Our Ref: 2922

Your Ref: MP05\_0062 MOD 2

**RE: MODIFICATION REQUEST FOR ROYAL NEWCASTLE HOSPITAL SITE**

### **Amended Concept Plan Drawing**

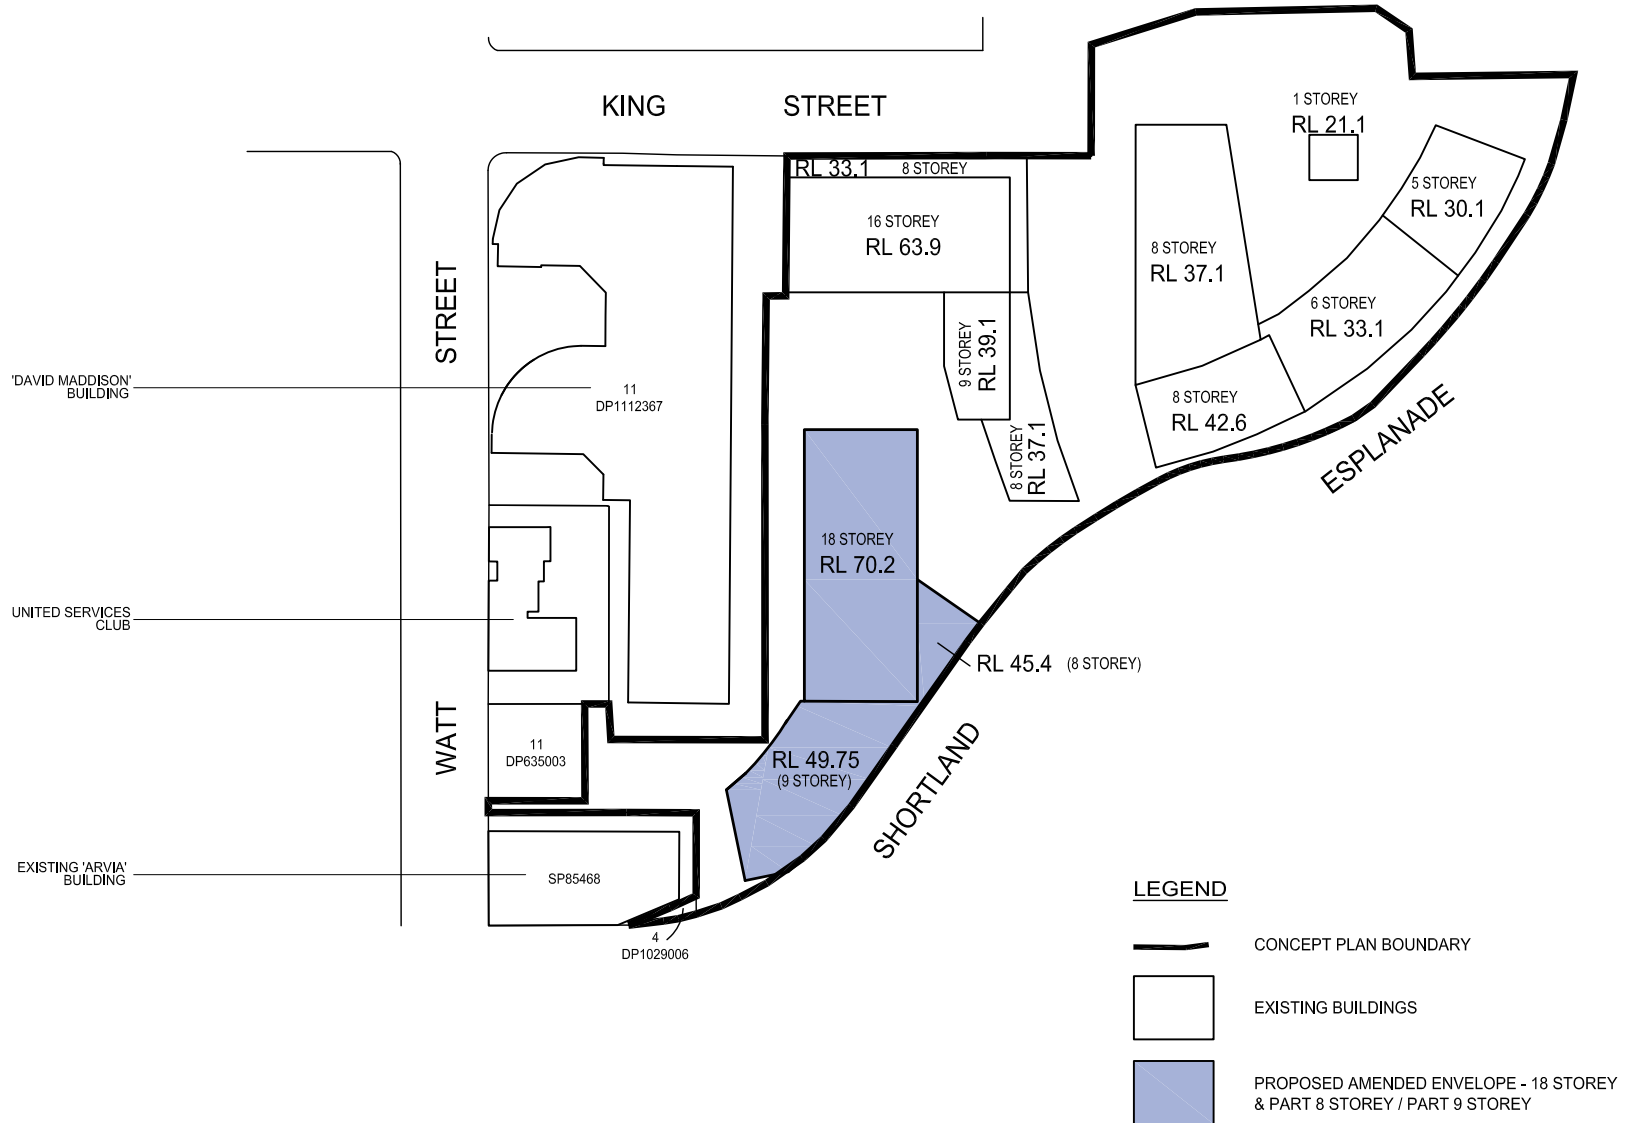
Taking into consideration the view sharing principles in *Tenacity Consulting vs Warringah* (2004) NSWLEC 140, it is proposed to splay the building envelope as per the revised building envelope drawing at **Attachment 1**. The impact of splaying the building envelope on views from the upper and lower levels of the Arvia building is demonstrated in the revised drawings PD 13 Issue D and PD 14 Issue D, prepared by Suturs Architects (**Attachment 2**). With respect to consistency between drawing Nos PD13 Issue D and PD14 issue D and previous revisions, the view of Arvia Lower Levels South Living- Existing MP and the marked line of existing MP envelope on Arvia Lower Levels South Living- Proposed MP, the architects have advised that the most recent revision is taken slightly back from the original submission, however the comparisons of existing and proposed in each issue are accurate. It is estimated that the "new point" has been moved by approximately 200mm. The keys in the updated drawings now reflect the altered view angle, notwithstanding that the change is indistinguishable to the naked eye.

With respect to the south western corner of the southern building envelope, any differences between the existing concept plan drawing and the proposed concept plan drawing are due to the proposed building envelope being accurately depicted based on CAD files obtained from Suturs showing the proposed building footprints within the envelopes as well as surveys undertaken for the site which accurately show boundary locations. The previous concept plan does not have the benefit of this level of accuracy. It should also be noted that the set back from the Arvia building is dictated by the Landcom Agreement at **Attachment 3** which refers to dimensions between the southern building and the Arvia building. These have been reflected in the proposed envelope for the southern building on the proposed concept plan and communal open space plan.

Drawing  
**ARVIA VIEW SHARING  
 ANALYSIS\_LOWER LEVELS**  
 Scale  
 1 : 4000 @ A3  
 Date Printed  
 31/10/2012 9:48:22 AM  
 Project Number  
 202485  
 Drawing Number  
 PD13  
 Issue  
 D

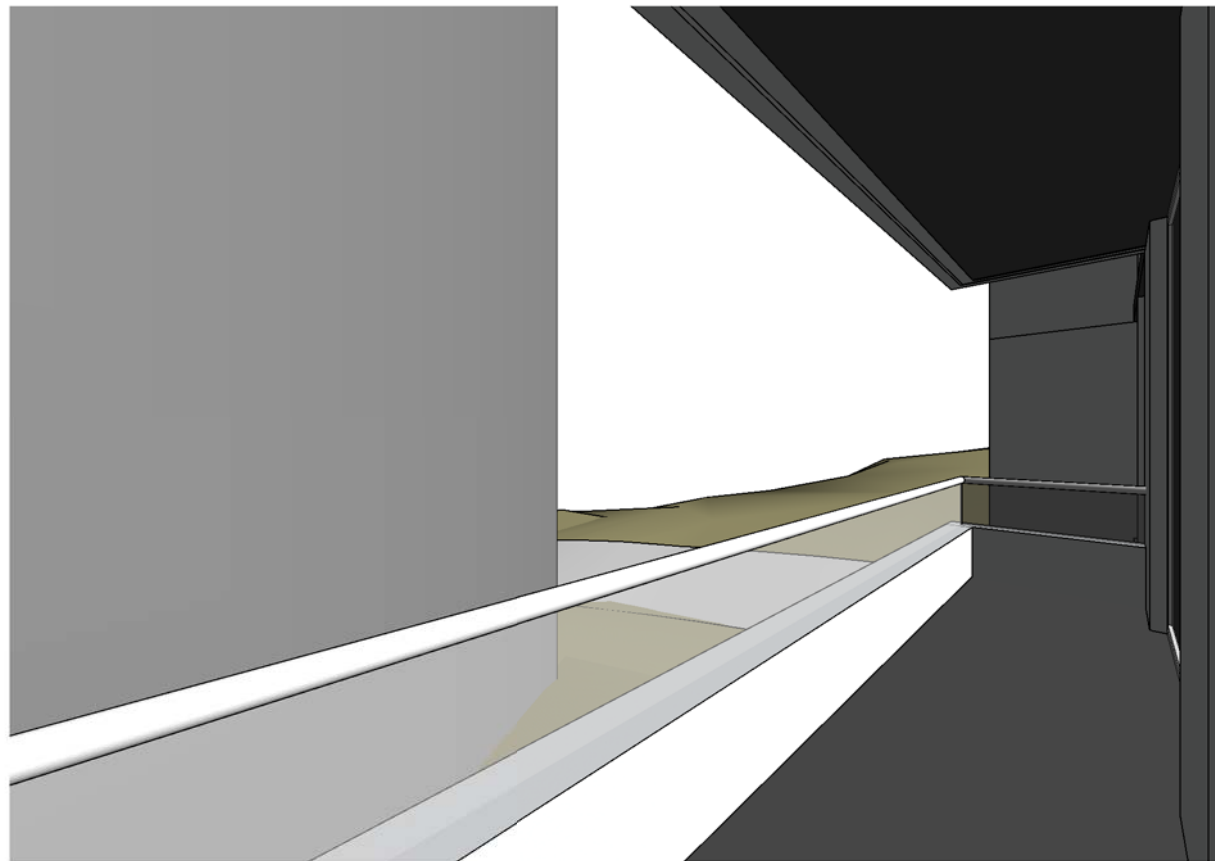
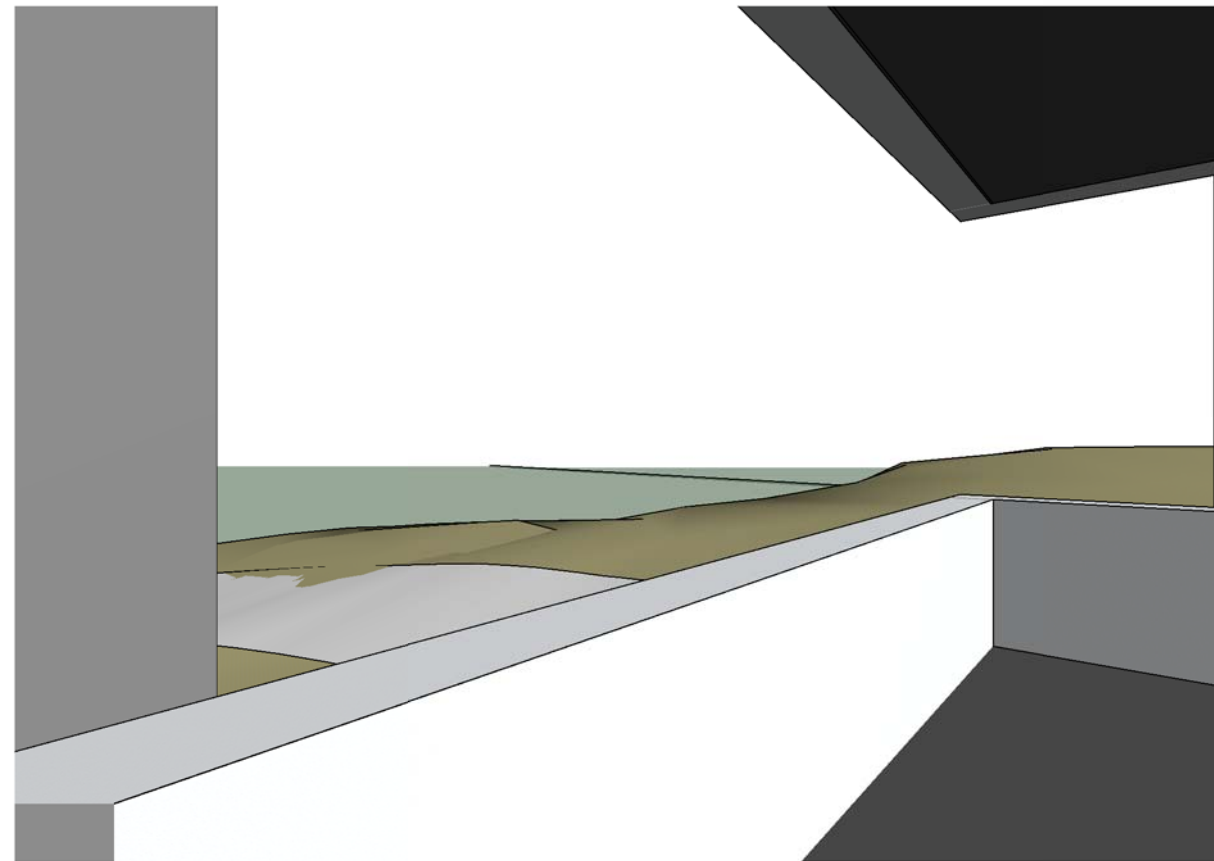
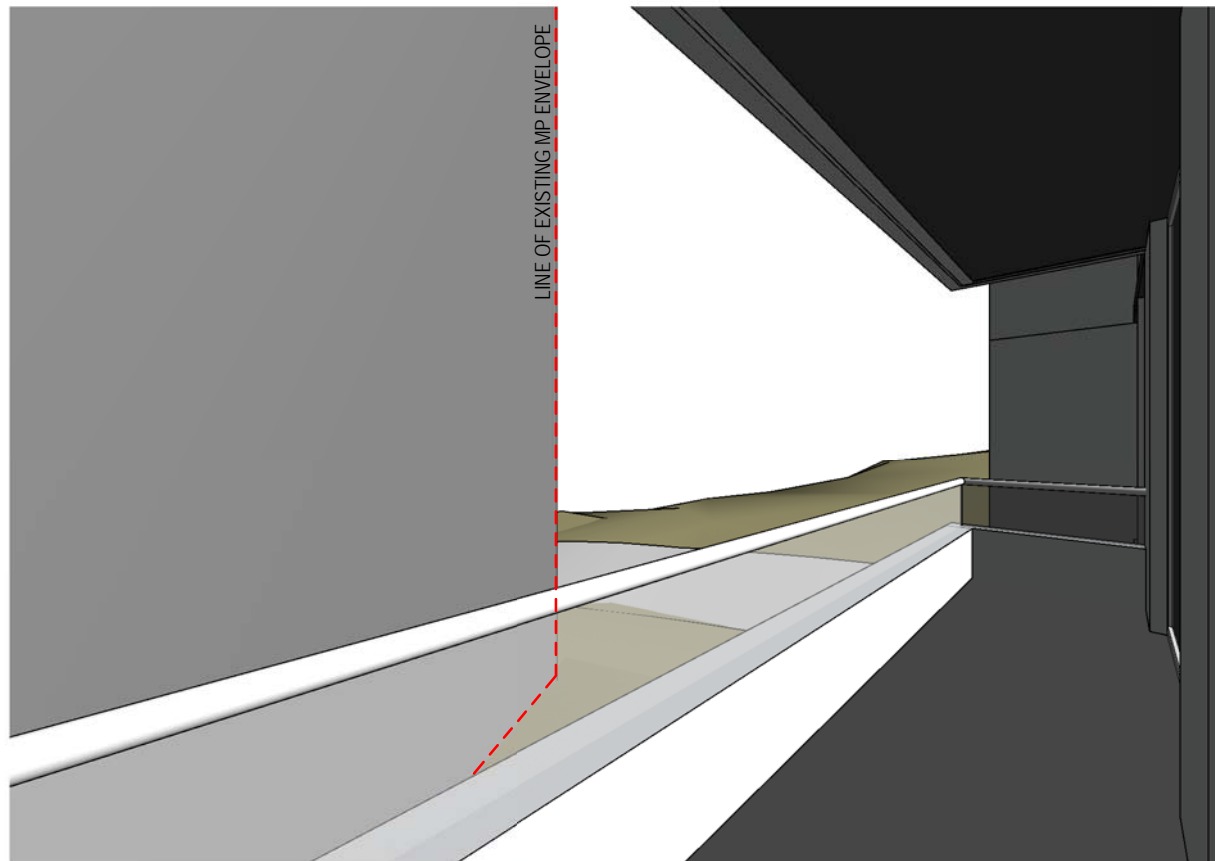
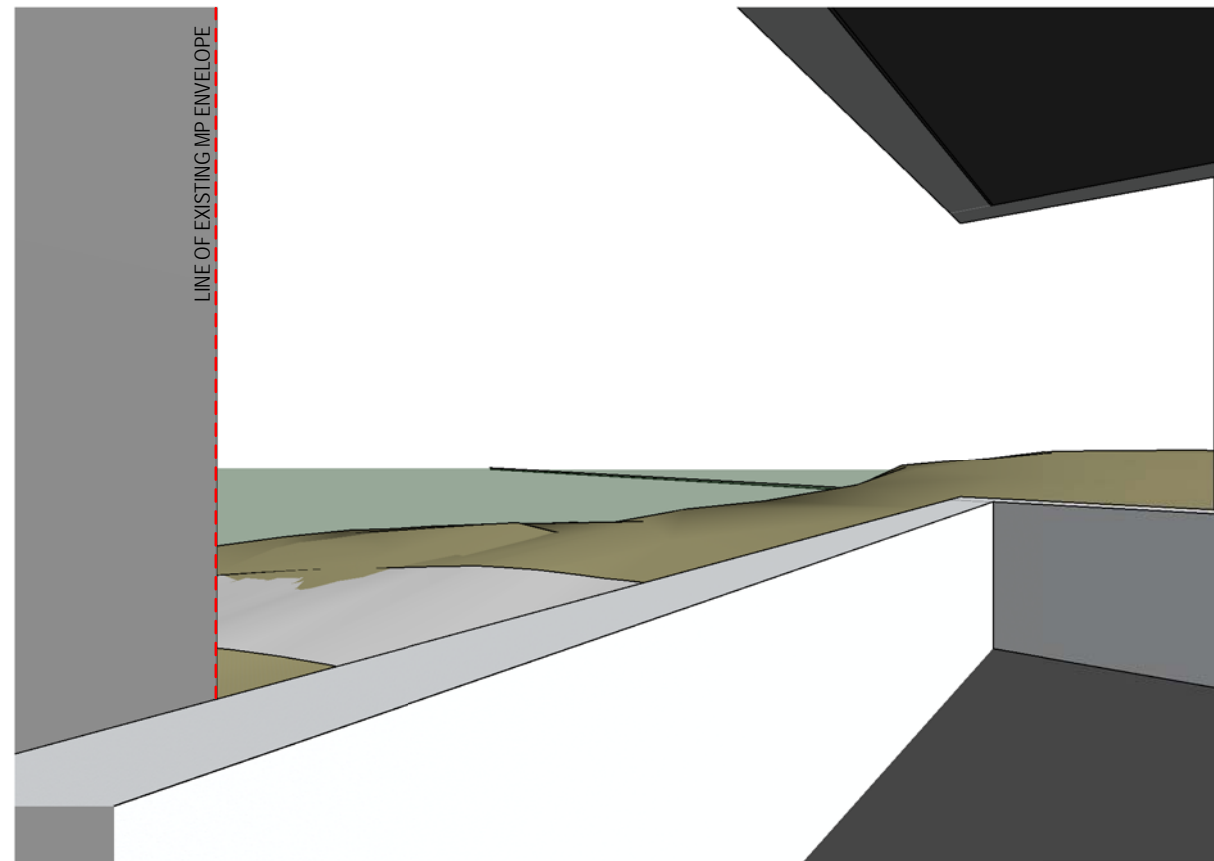
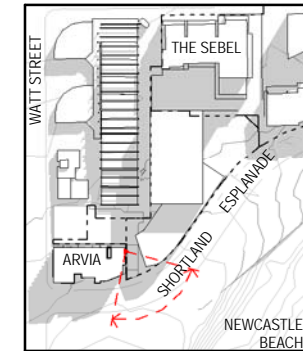
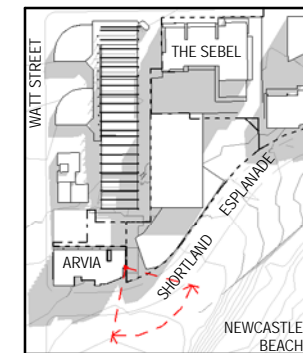
In relation to views from east facing units of the Arvia building which is located immediately west of the site, drawings PD 13 Issue B and PD 14 Issue B, prepared by Suturs Architects and submitted to the Department in a letter dated 14 August 2012, showed the line of the existing concept plan envelope and the extent to which adjusting the envelope in the south east corner of the southern building impacts on views from units in the Arvia building at both upper and lower levels.
